UNITED STATES PATENT AND TRADEMARK OFFICE

10/669,713

Office Action Summary	Application No. 10/669,713	Applicant(s) FUKUOKA ET AL.	
	Examiner Alix Elizabeth Echelmeyer	Art Unit 1795

DETAILED ACTION

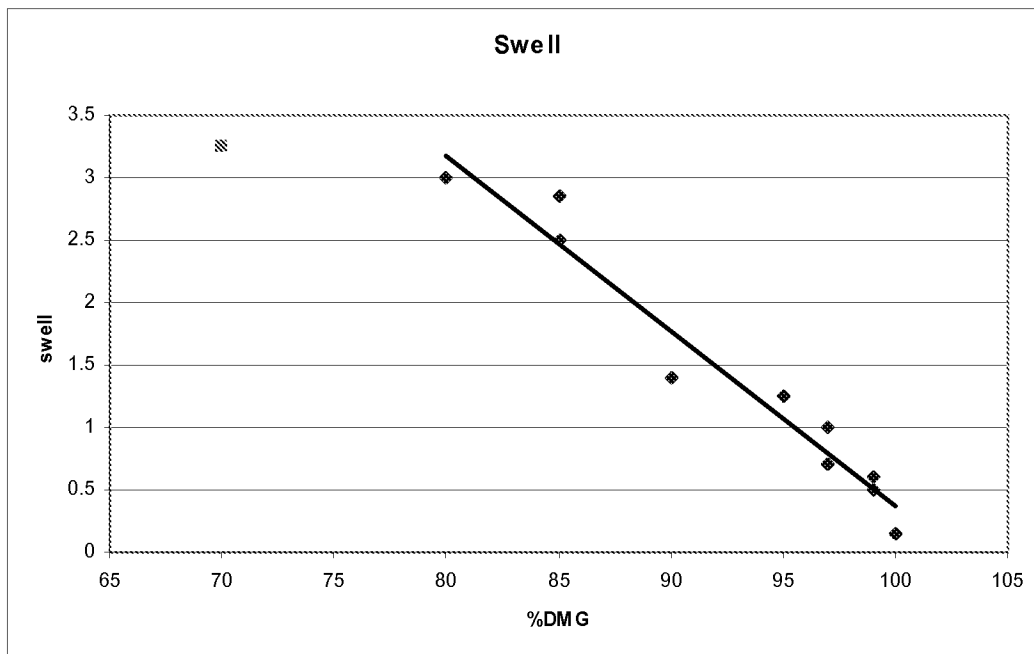
Beginning on page 5, Applicant argues that the invention as claimed provides unexpected results. The examiner disagrees.

In the Affidavit filed August 5, 2008, data of "comparative examples" has been provided. The examiner has reviewed the data and graphs that are found on page 4 of the affidavit. The examiner has also made graphs using the same data, seen below:

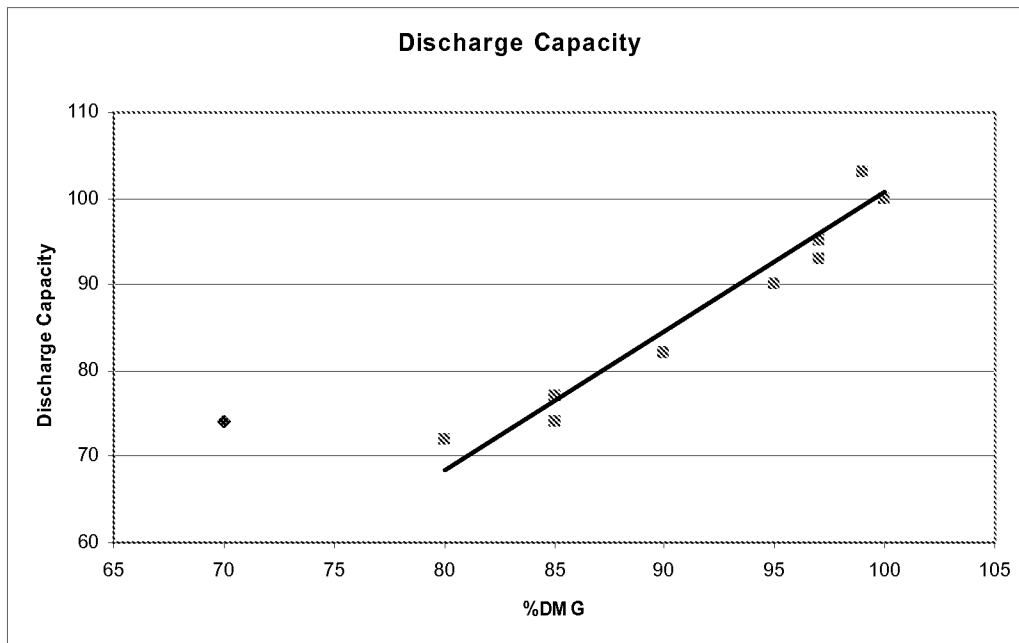
Based on a different linear regression line that includes BOTH the "comparative examples" and data from within the claimed ranges, it is clearly seen that a predictable result occurs. If Applicant still believes that the results are unexpected, data points in the range of 85-90% DGM would provide more data to be included in the calculation of the regression lines. As the data stands, the examiner is not at all convinced of Applicant's argument of unexpected results. If anything, the results at the data point of 70% DGM are unexpected, while the results within 80% to 100% DGM are predictable.
